From: "Paul Gunter" <pgunter@nirs.org>
To: <hga@nrc.gov>
Date: 07/26/2006 3:22:27 PM
Subject: Interim staff guidance on AMR of embedded steel containment at Oyster Creek

July 26, 2006

Memorandum

Subject: Oyster Creek, Drywell Liner
Embedded Region Issues

Schematic Drawing of Lower Spherical Section of Drywell Liner
(not to size)

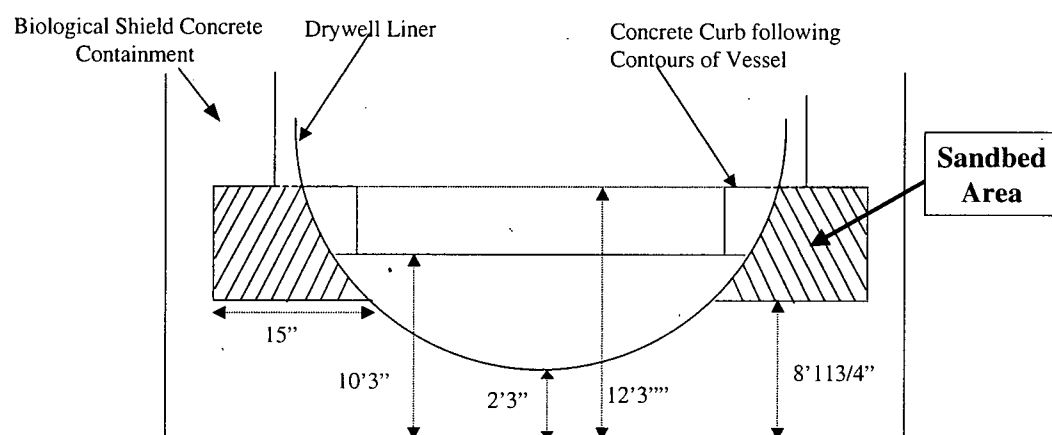
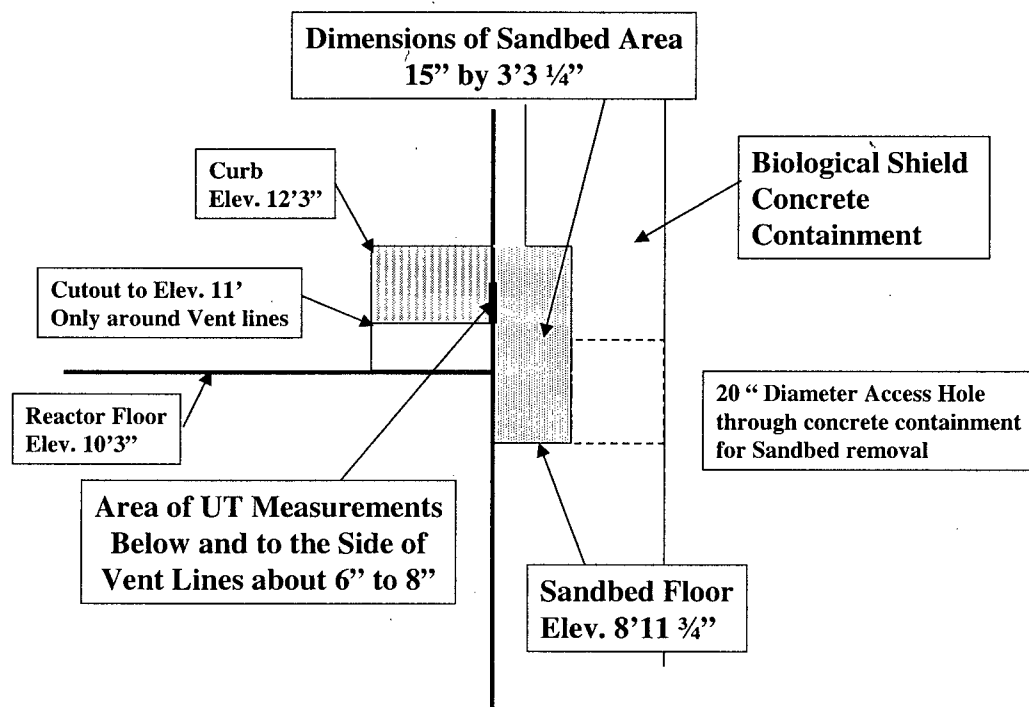
Figures 1 and 2 are sketches of the location of the sandbed area and its dimensions (Fig. 2). In view of the small access hole (20" diameter) and the even smaller sandbed dimensions (15" wide) and the resulting very confined work area one needs to wonder just how effective the repairs of the concrete floor and subsequent coating and sealing of the crevice might have been. Similarly, considering the extension of the sandbed area of 5 to 7 feet either side of the access hole, and its narrowness, one needs to ask just how thorough visual inspection can really be.
